DEVELOPMENT REVIEW COMMITTEE (DRC) COMMENT REPORT

PROJECT NAME: 11 Andrews

CASE NUMBER: UDP-S22023

REQUEST: Site Plan Level II Review: 425 Multifamily Residential Units and 7,400 Square Feet of Commercial Use in the Downtown Regional Activity Center

Principles of Building Design and Storefronts

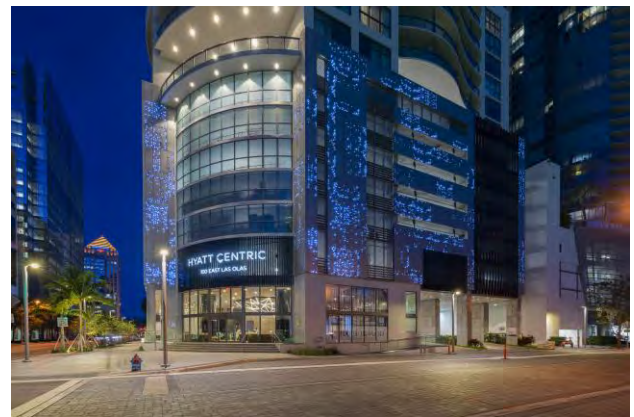
- d. B1, Streetwall Line; the placement of the building in relation Andrews Avenue due to dedications could be an issue and limits the amount of public realm and open space for the project. Examine the building placement and activity occurring on the ground level to meet this intent including back of house activity and use of the alley;
- e. B2, Framing the Street; there are landscape beds between the building and the sidewalk which appear to be leftover space or creates an impediment between the sidewalk and building;
- f. B12, Shading Devices; provide for continuous pedestrian shading canopies at a minimum of 5 feet in depth for protection from the elements; and
- g. B22, Ground Floor-to-ceiling Height; the first level floor-to-ceiling height should be increased give the scale and size of the overall project with emphasis on the northeast corner.
